5 November 2014  
Our Ref: 10034 75W Submissions Response.docx

### **Lakes Estate Residential Subdivision – Submission Report**

**ATTACHMENT 1**  
**Detailed response to submissions**

**MAP 5**  
**KOALA MANAGEMENT**

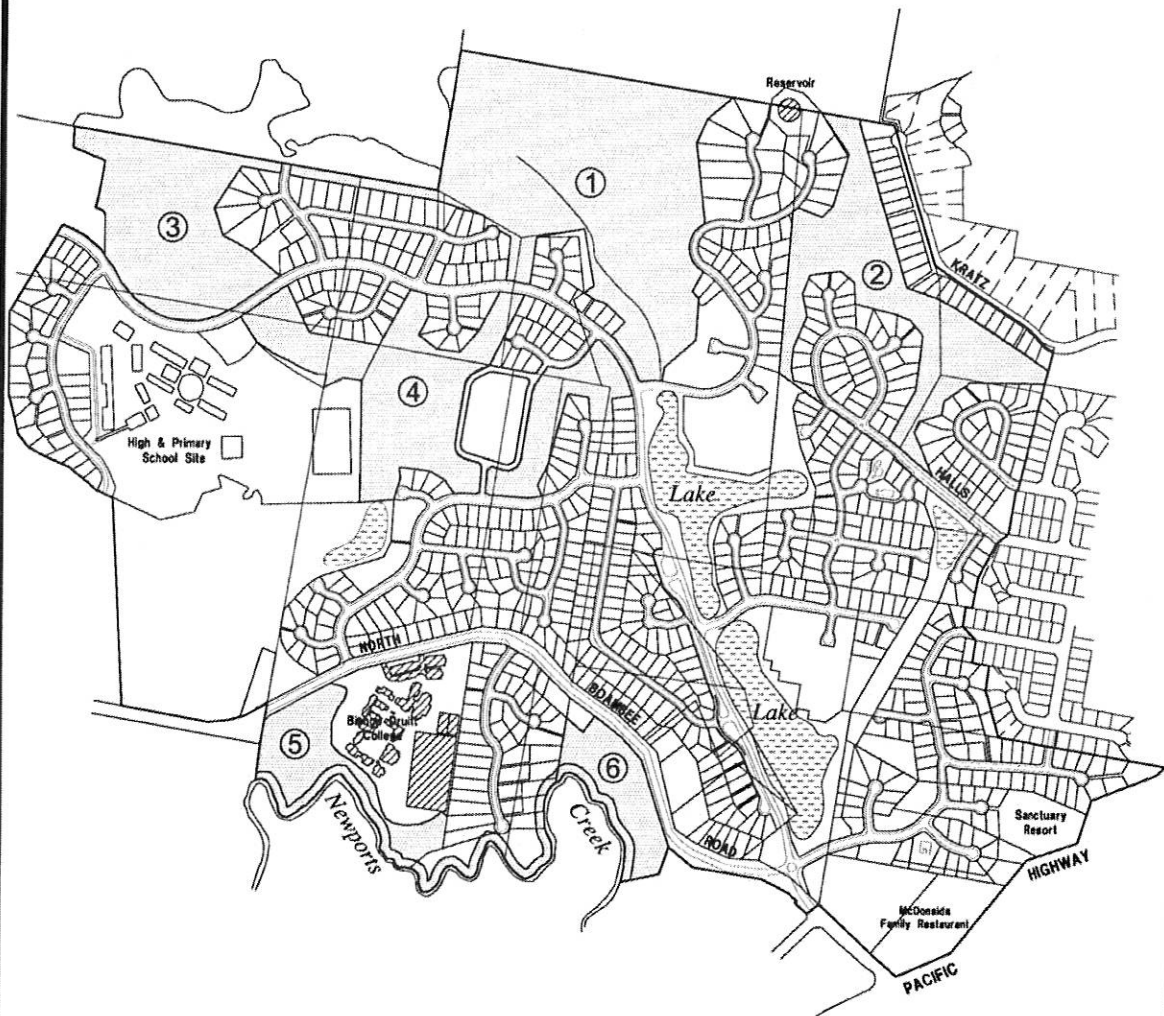
- Council submits that offset of [S94] contributions would only be considered after transfer of lands.
- However Council also submits that the value of the land should be established prior to offsets being agreed and Council is not obliged by the Act to accept the dedication in lieu of cash contributions in any case.
- Council refers to its Works in Kind Policy.

- Council's position is unreasonable.
- Council effectively submits that the land should be transferred after which the value of that land can be negotiated but Council could at that stage decide to not accept it as dedication in lieu of cash contributions required by its S94 Contributions Plan.
- The land required to be dedicated is the same land identified for acquisition by North Boambee Developer Contributions Plan.
- S94 of the Act provides:
